**SUBJECT:** R.E. Ginna Nuclear Power Plant  
Docket No. 50-244

**Final Response to Requests for Additional Information Regarding Topics  
Discussed on Conference Calls for Extended Power Uprate (EPU)**

**RESPONSE TO NRC REQUEST FOR ADDITIONAL INFORMATION ON THE R. E. GINNA  
EXTENDED POWER UPRATING**

**Figure 2.8.5.4.2-4**  
**Rod Withdrawal at Power – DNB Case**  
**Maximum Reactivity Feedback – 100% Power - 5 pcm/sec**  
**Nuclear Power and Heat Flux vs. Time**

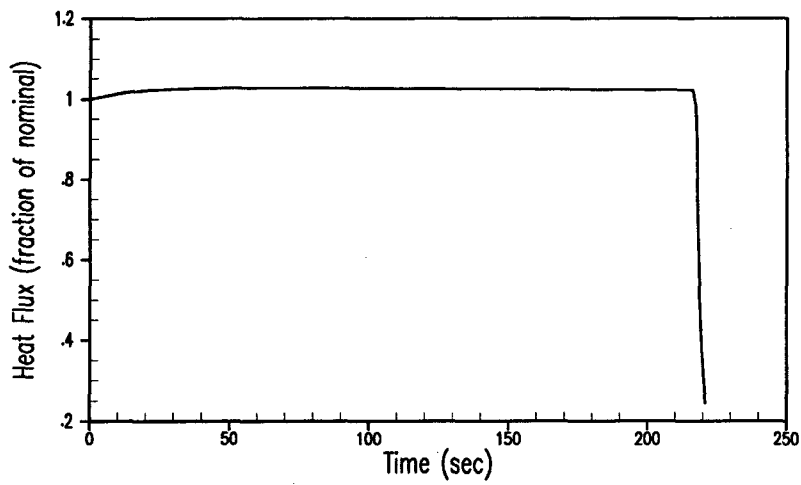
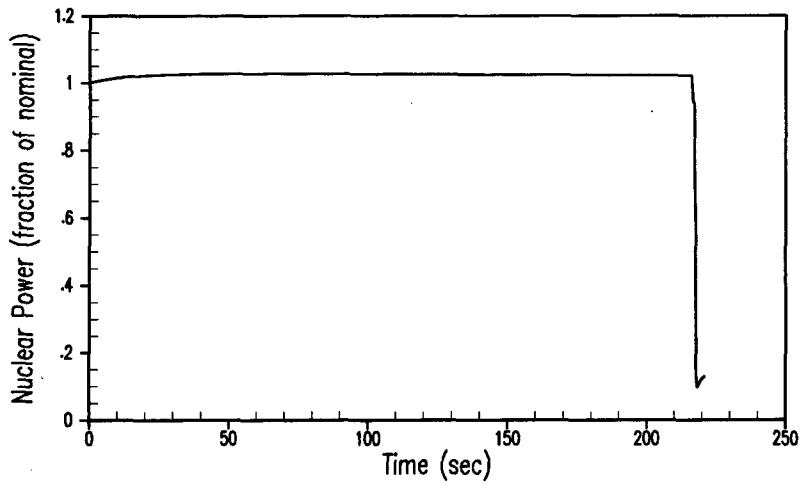
- Section 2.8.5.4.2.3 Results. In the second paragraph, the word 'minimum' should be 'maximum' (...from 100% power with maximumfeedback is shown in Figures 2.8.5.4.2-4...)
- Label for Figure 2.8.5.4.2-4 the word Minimum should be changed to Maximum.
- Label for Figure 2.8.5.4.2-5 the word Minimum should be changed to Maximum.
- Label for Figure 2.8.5.4.2-6 the word Minimum should be changed to Maximum.

Deleted: Minimum
